Technical Review Committee Agenda

**CITY OF DELAND
THURSDAY APRIL 18, 2024 AT 1:30 P.M.
CITY OF DELAND TRC MEETING ROOM
DELAND, FLORIDA**

**CITY OF DELAND
TECHNICAL REVIEW COMMITTEE MEETING
MEETING MINUTES
THURSDAY, MARCH 21, 2024 - 1:30 P.M.
CITY HALL**

City of DeLand
SP23-207
FLEX WAREHOUSE

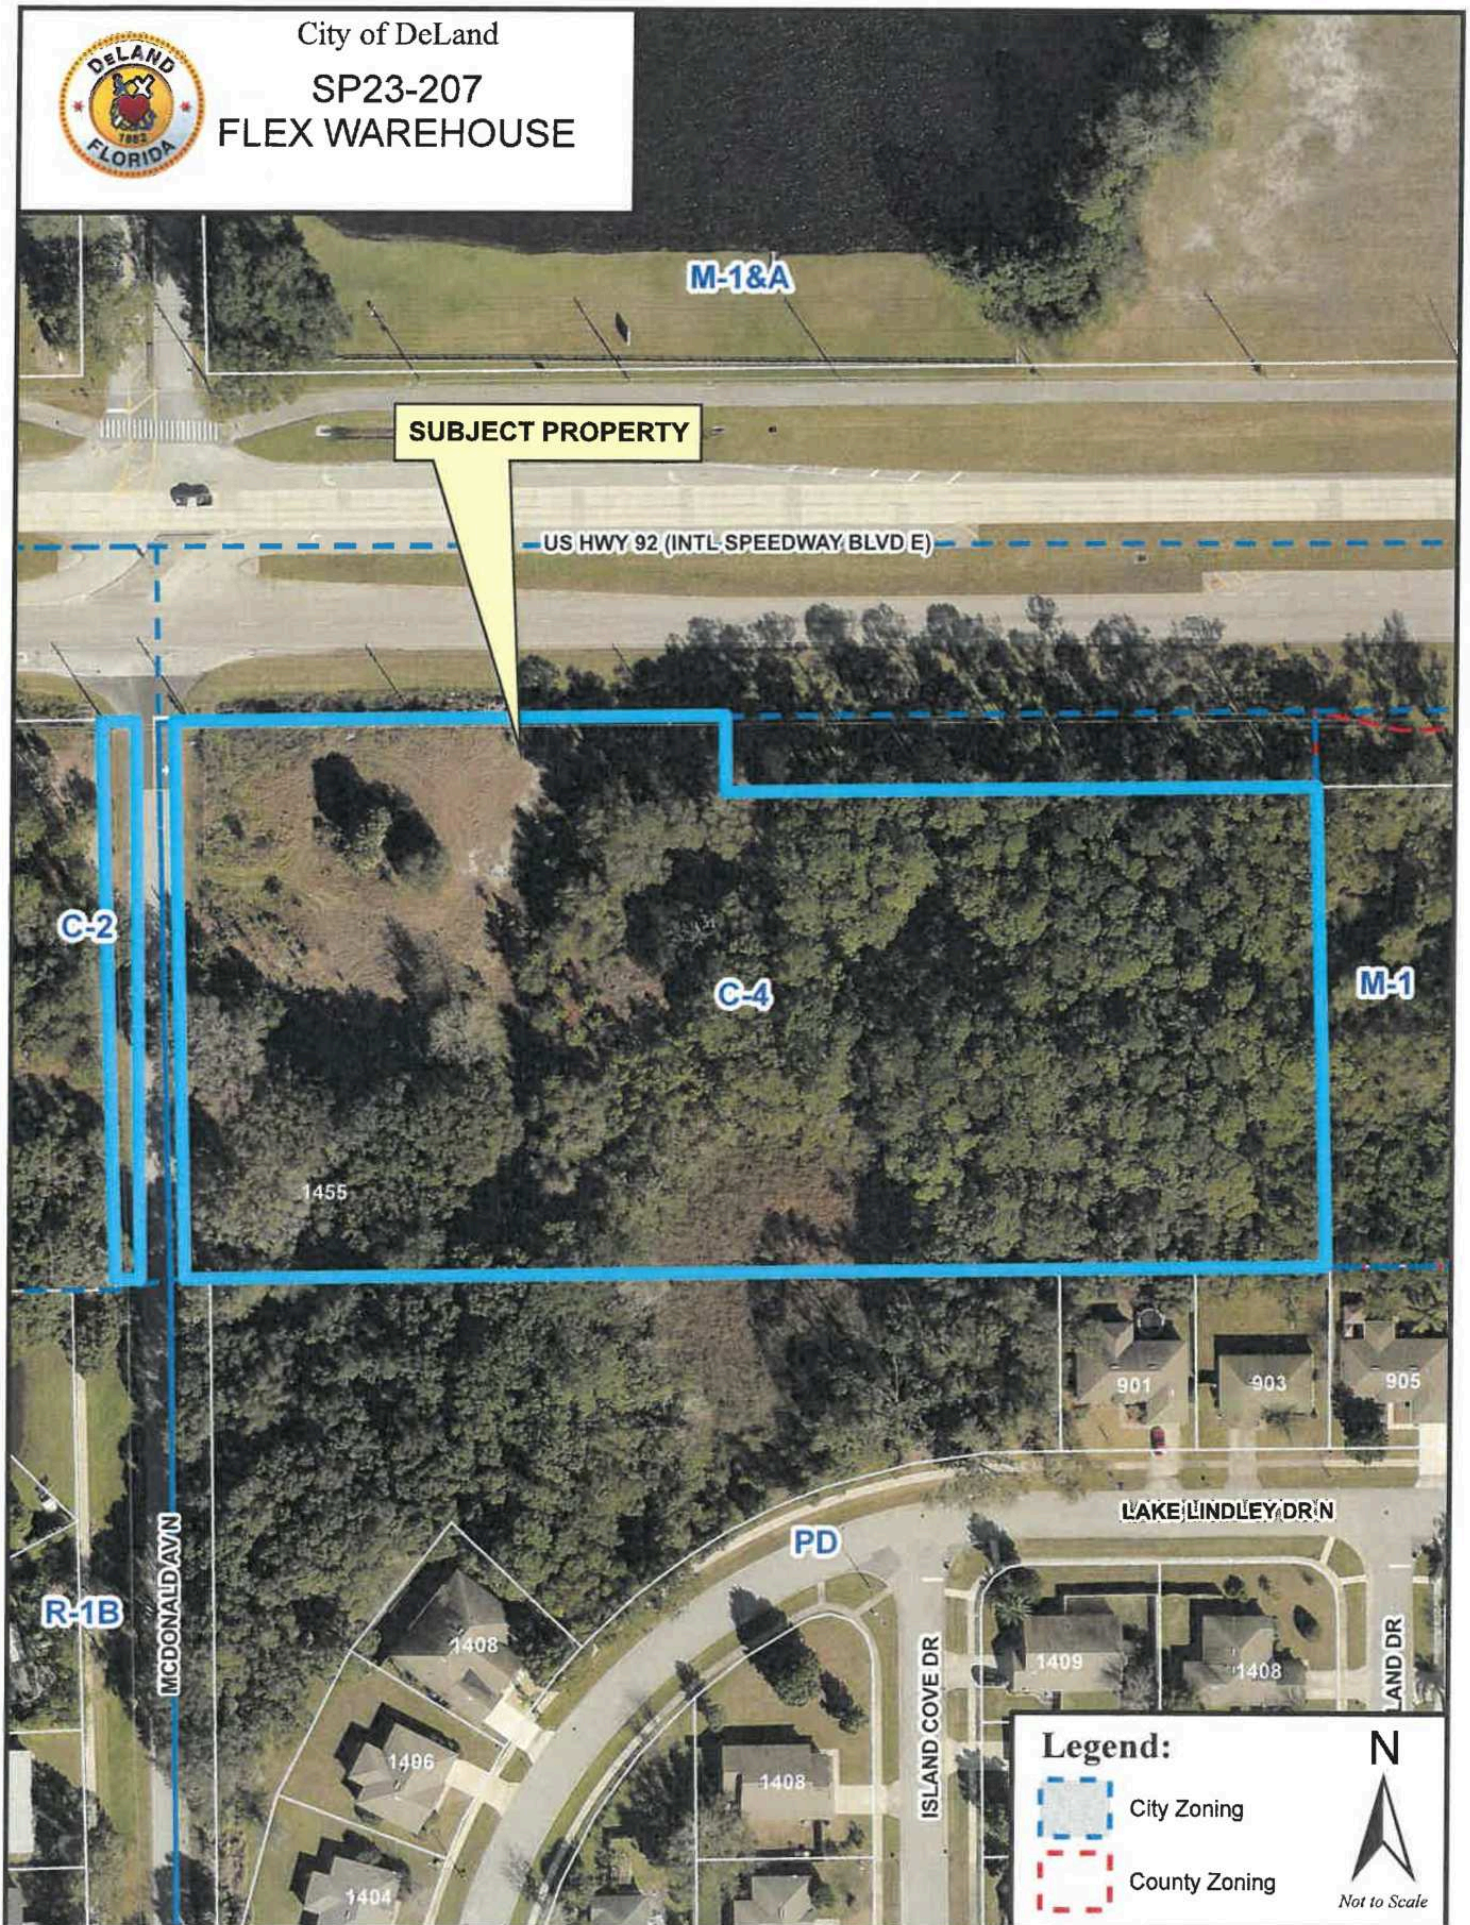
Discipline	Status	Details	Attached To	Created By	Last Updated By	Modifications Required
Engineering	Draft	Curve Number Given that nearly half of the site becomes impervious in the post-development condition, the post-development CN should be greater than the pre-development condition.	Stormwater Management Report (1455 N McDonald Ave).pdf	Steven Danskine	Steven Danskine	Yes
Engineering	Draft	Retaining Wall Information Provide Retaining Wall information and details.	C401	Steven Danskine	Steven Danskine	Yes
Engineering	Draft	Subgrade Thickness The Geotech Report recommends a minimum 12" compacted subgrade rather than the 10" shown in the Typical Pavement Section detail.	C602	Steven Danskine	Steven Danskine	Yes
Engineering	Draft	Roof Drains Provide details for handling roof runoff. Only Building 4 appears to have a roof drain, but no details seem to be provided.	C401	Steven Danskine	Steven Danskine	Yes

Engineering	Draft	Pavement Grading The minimum practical slope for asphalt is 1.5% to avoid ponding and bird baths, and to achieve flow.	C401	Steven Danskine	Steven Danskine	Yes
Engineering	Draft	Permits Provide the City with an FDOT Drainage Connection Permit and SJRWMD ERP Permit prior to scheduling a Pre-Construction Meeting.	C101	Steven Danskine	Steven Danskine	Yes
Engineering	Draft	Wetland Buffer It appears that no 25' Wetland Buffer has been provided.	C301	Steven Danskine	Steven Danskine	Yes
Engineering	Draft	Right of Way Ownership The McDonald Ave Right of Way has recently been turned over to the City of DeLand.	SU-1	Steven Danskine	Steven Danskine	Yes
Engineering	Draft	Handicap Parking Minimum Handicap Parking stall depth is 20'.	C301	Steven Danskine	Steven Danskine	Yes
Engineering	Draft	NPDES NOI The Contractor will be required to submit a Notice of Intent to FDEP and provide the City with a copy.	C201	Steven Danskine	Steven Danskine	Yes

Discipline	Status	Details	Attached To	Created By	Last Updated By	Modifications Required
Forestry	Draft	Laurel Oak Laurel Oaks are not on our list of approved replacement trees and will not be counted towards replacement provided. You will need to change them to canopy trees from our list or add the required number of canopy trees with trees from the list. The tree listed here should also match what is shown in the Proposed Trees table on sheet L102.	L101	Kit Dennis	Kit Dennis	Yes
Forestry	Draft	Irrigation Plan An irrigation plan is needed.		Kit Dennis	Kit Dennis	Yes
Forestry	Draft	Mitigation Calculations Mitigation for remove trees cannot be calculated until a complete tree survey and spreadsheet identifying removals has been provided.	I64	Kit Dennis	Kit Dennis	Yes
Forestry	Draft	Minimum Coverage You are proposing the wetlands as Tree Protection Area. The wetland area will need to be included in the calculations. Including this area will bring the minimum coverage requirement to 77 trees and 462" DBH. We cannot determine if minimum coverage will be met until a complete tree survey, including the wetlands, has been provided.	I63	Kit Dennis	Kit Dennis	Yes

Forestry	Draft	Planting/Grading vs Historic Trees It appears that you are proposing a retention area and planting of additional trees within the protection area required for historic trees. No disturbance is permitted in an area of 1 1/2 times the dripline of Historic trees that are to be preserved.	L101	Kit Dennis	Kit Dennis	Yes
Forestry	Draft	Historic Tree Protection Area The protection area for the historic trees needs to be shown on the plan. The area to be	L102	Kit Dennis	Kit Dennis	Yes

Discipline	Status	Details	Attached To	Created By	Last Updated By	Modifications Required
protected for historic trees is 1 1/2 times the dripline.						
Forestry	Draft	Silt Fence/Tree Barricade Locations Locations of the silt fence and tree barricades need to be shown and identified on the plan.	L102	Kit Dennis	Kit Dennis	Yes
Forestry	Draft	Tree Protection Area Please identify the Tree Protection Area on the plan.	L102	Kit Dennis	Kit Dennis	Yes
Forestry	Draft	Crape Myrtle 2" caliper Crape Myrtles do not meet our minimum replacement specifications. Our minimum replacement size is 2" DBH (3" caliper). Planted trees must meet Grade 1 standards as provided in the Florida Grades and Standards for Nursery Plants 2022 version for the type and caliper of the proposed trees. 3" caliper would equate to 2" DBH credit.	L102	Kit Dennis	Kit Dennis	Yes
Forestry	Draft	Proposed Trees Removal of specimen trees require canopy trees as replacement. You are only proposing understory trees.	L102	Kit Dennis	Kit Dennis	Yes

Forestry	Draft	Oaks Identify "oaks" by species.	L102	Kit Dennis	Kit Dennis	Yes
Forestry	Draft	Historic Tree Barricade Detail Because there are historic trees on the site, you will need to add the City's Historic Tree Barricade Detail to the plans. It can be found on the City's website.	L102	Kit Dennis	Kit Dennis	Yes
Forestry	Draft	Tree Barricade Detail Replace the Tree Protection Barricade detail with the City's Tree Barricade Detail. It can be found on our website.	L102	Kit Dennis	Kit Dennis	Yes
Planning	Draft	Retaining Wall Please provide a detail of the proposed retaining wall and show the height.	C201	Samuel Nelson	Samuel Nelson	Yes
Planning	Draft	Building Height Please include the proposed height of the buildings in a data table.	C301	Samuel Nelson	Samuel Nelson	Yes
Planning	Draft	Stormwater in the Landscape Buffer A stormwater retention area may not be located within the required landscape buffer. Revise the submittal to remove the proposed retention area.	C301	Samuel Nelson	Samuel Nelson	Yes

Planning	Draft	Parcel Dimensions Please provide the linear dimensions of the parcel.	C301	Samuel Nelson	Samuel Nelson	Yes
Planning	Draft	Office Use Parking The requirement for office use parking is 1 space per 200 square feet of net floor area.	C301	Samuel Nelson	Samuel Nelson	Yes

Discipline	Status	Details	Attached To	Created By	Last Updated By	Modifications Required
Please update the parking calculation to reflect the correct number.						
Planning	Draft	Development Schedule Are the proposed warehouses to be constructed concurrently, or sequentially?		Samuel Nelson	Samuel Nelson	Yes
Planning	Draft	Right-of-Way Dedecation Portions of the subject property will need to be dedicated to the City for the widening of N McDonald Ave. The portion dedicated will cause the width of the section of North McDonald Ave bordering the subject property to match the width of the North McDonald Ave to the south. The entire western portion of the property that is separated from the main parcel by McDonald Ave will need to be dedicated.		Samuel Nelson	Samuel Nelson	Yes
Planning	Draft	McDonald Ave Information The property boundary shown appears to include McDonald Ave. Additionally, the lot area table includes the area of McDonald Ave. Please remove McDonald Ave from the site data calculations.	C301	Samuel Nelson	Samuel Nelson	Yes

Planning	Draft	Exterior Wall Mounted Lighting Please show any exterior wall mounted lighting on the photometric plan and update the photometric plan to include this wall mounted lighting. Please provide details for any proposed lighting and confirm any proposed lighting conforms to the standards of Sec. 33-94.03 (g)	E1	Samuel Nelson	Samuel Nelson	Yes
Planning	Draft	Setback Requirements The setback requirements shown do not match the requirements of 33-17-20, C-4—Wholesale Commercial District. Please revise the table to show the correct information.	C301	Samuel Nelson	Samuel Nelson	Yes
Planning	Draft	Interior & Vehicle Use Landscaping Requirements Please provide a data table showing what is provided and required for vehicle use area and interior landscaping.	L101	Samuel Nelson	Samuel Nelson	Yes
Planning	Draft	Western Landscape Buffer The western buffer abutting N McDonald Ave is required to meet the Buffer Standard "D" Requirements. Please include a data table for this buffer showing how the requirement is being met.	L101	Samuel Nelson	Samuel Nelson	Yes

Planning	Draft	Dumpster Enclosure Detail Please include a detail specific to the dumpster enclosure showing materials and color of the enclosure and doors.	C602	Samuel Nelson	Samuel Nelson	Yes
Planning	Draft	Future Land Use Callout The current future land use designation of the property is Industrial. Please revise the callout to reflect this.	C301	Samuel Nelson	Samuel Nelson	Yes
Planning	Draft	Proposed Signage Please show any proposed free-standing or wayfinding signage. Note: Any signage shown will be for illustrative purposes only, a separate sign permit will be required.	C301	Samuel Nelson	Samuel Nelson	Yes

Discipline	Status	Details	Attached To	Created By	Last Updated By	Modifications Required
Planning	Draft	Building Dimensions Please show the building length, width, and height dimensions on the building elevations.	A300A	Samuel Nelson	Samuel Nelson	Yes
Planning	Draft	Roof Mechanical Equipment. Is rooftop mechanical equipment proposed? If so, all rooftop mechanical equipment shall be screened. Show all rooftop mechanical equipment as dashed lines behind a screened wall.	A300A	Samuel Nelson	Samuel Nelson	Yes
Planning	Draft	Community Design Review *City Architect approved the Community Design Review 4-10-24*		Samuel Nelson	Samuel Nelson	Yes
Planning	Draft	Northern Landscape Buffer The northern buffer abutting International Speedway Blvd is required to meet the Emerging Gateway District—Buffer Standard "D" Requirements. The buffer proposed does not appear to meet the 40 feet width requirement. Additionally, no plant material is shown in the buffer. Please revise to include the required plant material on the plan and show the totals in a data table.	L101	Samuel Nelson	Samuel Nelson	Yes

Planning	Draft	Building Number Discrepancy Plans show a "Building 4" where the data tables reference a "Building 3" Please revise to reflect the correct numbering.	C301	Samuel Nelson	Samuel Nelson	Yes
Planning	Draft	Building Size Discrepancy The square footage of each building shown on this cover sheet table do not match what is shown on subsequent plans. Please revise to reflect the correct area.	C101	Samuel Nelson	Samuel Nelson	Yes
Planning	Draft	Tree Protection Area Please show the intended tree protection area on the plan and add a table showing the percentage of the site to be dedicated to tree protection area. 33-57.07 (b)	L102	Samuel Nelson	Samuel Nelson	Yes
Planning	Draft	Bicycle Parking Bicycle racks are shown on the site plan. Please include the total number of bicycle parking spaces in the parking table.	C301	Samuel Nelson	Samuel Nelson	Yes
Planning	Draft	Parking in the Landscape Buffer Parking may not be located in the landscape buffer area. Please relocate or remove the shown parking.	C301	Samuel Nelson	Samuel Nelson	Yes

Planning	Draft	Future Development Is the eastern portion of the property intended to be developed in the future, or is a borrow pit as shown in the note the intention? Please elaborate on the plan for this property.	C301	Samuel Nelson	Samuel Nelson	Yes

Discipline	Status	Details	Attached To	Created By	Last Updated By	Modifications Required
Planning	Draft	Emerging Gateway Buffer The required buffer for the Emerging Gateway Corridor off International Speedway is 40' from the property line. Please show that this is being met.	C301	Samuel Nelson	Samuel Nelson	Yes
Planning	Draft	Building Setbacks Please show the setbacks for each proposed building from each property line on the site plan.	C301	Samuel Nelson	Samuel Nelson	Yes
Planning	Draft	Lighting Requirements Please update the photometric plan to include the entire property and show foot-candle data up to the right-of-way and adjacent property lines.	E1	Samuel Nelson	Samuel Nelson	Yes
Utilities	Draft	USA This project will require a Utility service Agreement to be signed prior to starting construction.	C101	Jim Alles	Jim Alles	Yes
Utilities	Draft	Details Need updated details dated 11/7/23	C606	Scott Zender	Scott Zender	Yes

City of DeLand
SP24-064
5 TOWNHOMES

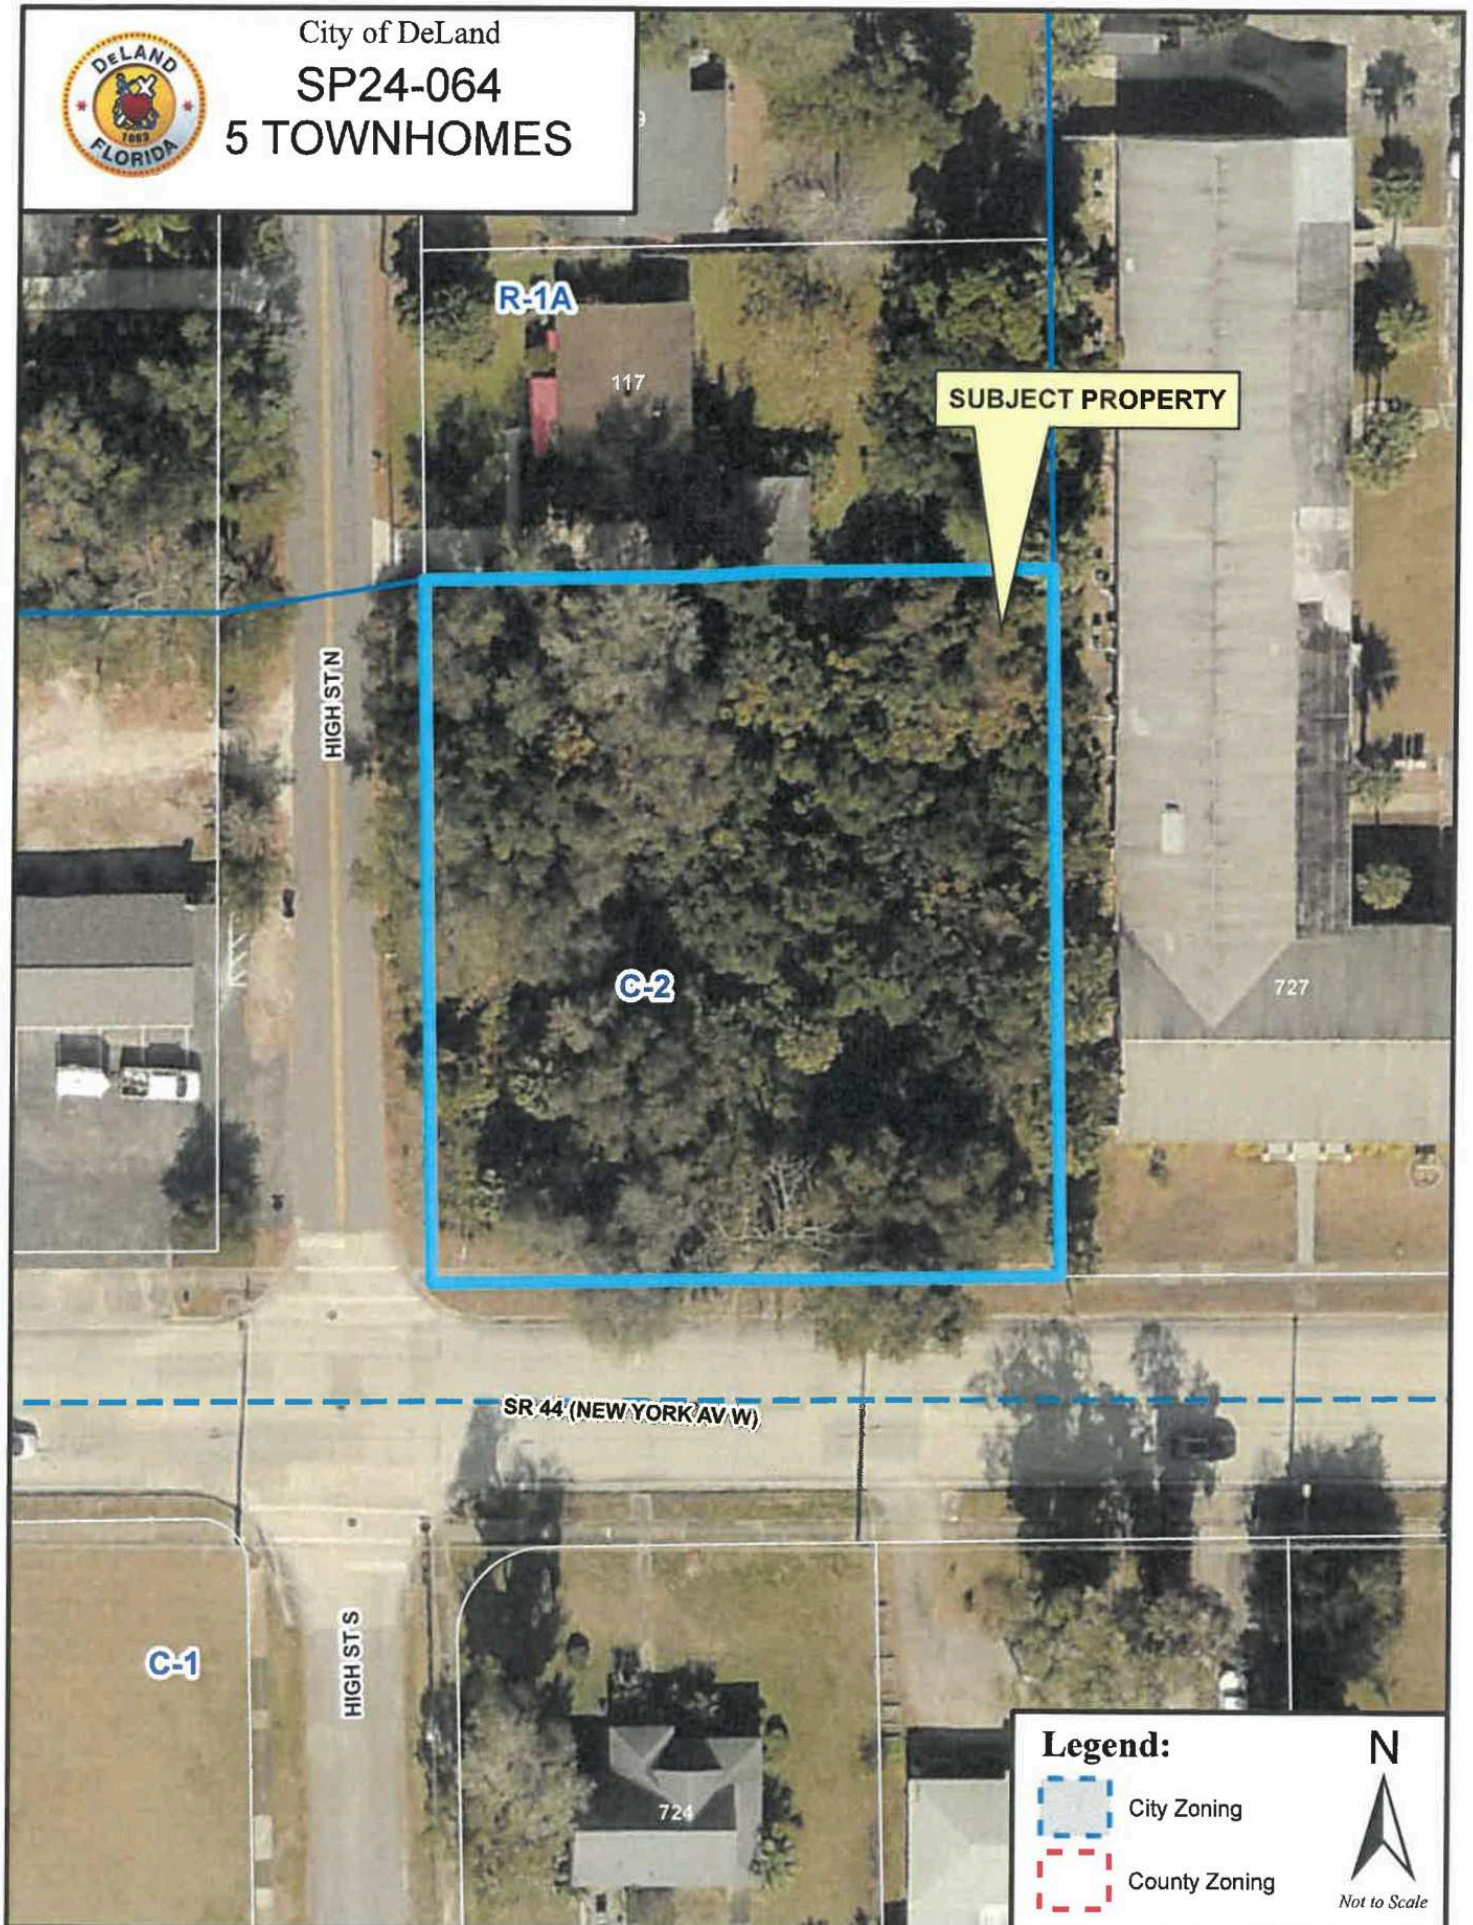
Discipline	Status	Details	Attached To	Created By	Last Updated By	Modifications Required
Vehicle Access						
Engineering	Draft	1. The driveway apron must have a minimum thickness of 6-inches and strength of 3,000 psi.	C1	Steven Danskine	Steven Danskine	Yes

2. Provide details and dimensions to facilitate evaluation of vehicle access and maneuvering.				
Agency Permits						
Engineering	Draft	Provide FDOT Drainage Connection and St Johns River Water Management District Environmental Resource Permit prior to scheduling a Pre-Construction Meeting.	C1	Steven Danskine	Steven Danskine	Yes
Stormwater Design						
Engineering	Draft	1. Provide a positive outfall for stormwater discharge that will not adversely impact downstream properties.	C1	Steven Danskine	Steven Danskine	Yes

2. The maximum slopes allowed are 4:1 (H:V). The swale details shown exceed this requirement.				
		3. Provide spot elevations and details necessary to evaluate pavement design. Minimum slopes vary based upon surface material.				
Stormwater Calculations						
Engineering	Draft	1. Provide Stormwater Calculations that meet Section 33-93 – Stormwater Management of the Land Development Code. 2. The Storm Water Calc. Q=CiA provided is the Rational Method which calculates runoff rate (cfs), not volume (cf).	C1	Steven Danskine	Steven Danskine	Yes
Japanese Blueberry / Grape Myrtle						
Forestry	Draft	These would not meet the size specifications to be counted towards replacement or minimum coverage requirements. Our code minimum is 2" DBH (3" caliper) and 10' height.	C3	Kit Dennis	Kit Dennis	Yes
Landscape Material						
Forestry	Draft	The trees shown on this page do not match what is shown in your replacement tree chart on sheet C2. The information needs to match throughout the plan.	C3	Kit Dennis	Kit Dennis	Yes

Landscape Notes						
Forestry	Draft	#9 – This should be edited to show the correct code section from the City of DeLand's code.	C3	Kit Dennis	Kit Dennis	Yes

Discipline	Status	Details	Attached To	Created By	Last Updated By	Modifications Required
#10 - This is also from another jurisdictions code. #11 - This is an acceptable method providing a watering schedule is provided. Please provide a watering schedule.						
Mitigation Calculations						
Forestry	Draft	Your plan requires 33" DBH replacement. I cannot calculate if your planting plan will meet the requirement until the proposed tree issues have been resolved. The information in the replacement tree chart does not match what is shown on sheet C3. In addition to the proposed DBH, you will need to include the height, spread, and root ball or container size for the planting material. The specs must meet Grade 1 Standards as provided in the latest edition of the Florida Grades and Standards for Nursery Plants.	C2	Kit Dennis	Kit Dennis	Yes
Specimen Tree Requirements						
Forestry	Draft	You show 10 specimen trees on your .52 AC site. You would be required to preserve at least 5 specimen trees. You are preserving 8 specimen which would be sufficient. The information in your table needs to be corrected. The minimum coverage requirement for your site is 9 trees, not the specimen requirement.	C2	Kit Dennis	Kit Dennis	Yes

Sidewalks vs Trees						
Forestry	Draft	You are proposing to install sidewalks within the protection area of a historic tree and others that are to remain. Can the sidewalk be reconfigured in order to protect the trees.	C2	Kit Dennis	Kit Dennis	Yes
Silt Fence						
Forestry	Draft	Show the location of the silt fence on the plan.	C1	Kit Dennis	Kit Dennis	Yes
Tree Barricade Locations						
Forestry	Draft	Show the location of the tree barricades on the plan. 10' or the dripline (whichever's greater) must be protected for existing trees that are to remain. 1 1/2 times the dripline must be protected for historic trees.	C1	Kit Dennis	Kit Dennis	Yes
Tree Barricade Details						
Forestry	Draft	Add the City's Tree Barricade Detail and the City's Historic Tree Barricade Detail to the plans. The details can be found on our website.	C1	Kit Dennis	Kit Dennis	Yes
Grading/Fill Near Existing Trees						
Forestry	Draft	It appears you are proposing grade changes in the required protection area of historic trees and within the Tree Protection Areas. No grade changes are permissible within the protection area of historic trees (1 1/2 times the dripline) or within Tree Protection Areas where existing trees are to be preserved. I'd recommend hiring a Certified Arborist to make a preservation plan to ensure the affected trees survival if the grade changes cannot be avoided.	C1	Kit Dennis	Kit Dennis	Yes

COMMENT - The architectural character of the proposed building is not in keeping with that of the surrounding area. Provide documentation supporting the proposed design.

COMMENT - This standard is not met as explained above.

COMMENT - Verify if any signage will be provided for this project.

COMMENT - The architectural character of the proposed building is not in keeping with that of the surrounding area.

COMMENT - Verify which three of these were used.

COMMENT - Provide the building colors to be used.

COMMENT - The roof type proposed does not meet the intent of this standard.

COMMENT - The architectural character of the proposed building does not complement the surrounding area as stated above.

1. Identify which live oaks are existing and are to be maintained and which are new.
2. Name the variety of the other trees included on the plans.
3. This property is located in the Core Gateway and there is a requirement to provide a 15-foot buffer along the street frontage.
4. This property is located in the Core Gateway and there is a requirement to use Buffer Standard "A" along the overlay street frontage and provide 3 canopy trees, 1 shade trees and 9 shrubs along New York Ave. and 3 canopy trees, 1 shade trees and 9 shrubs along High St.

How is the proposed site planned to be irrigated?

How will manhole tap be done or is it existing and not called out on plans.

Need to add the latest utility details dated 11/7/23
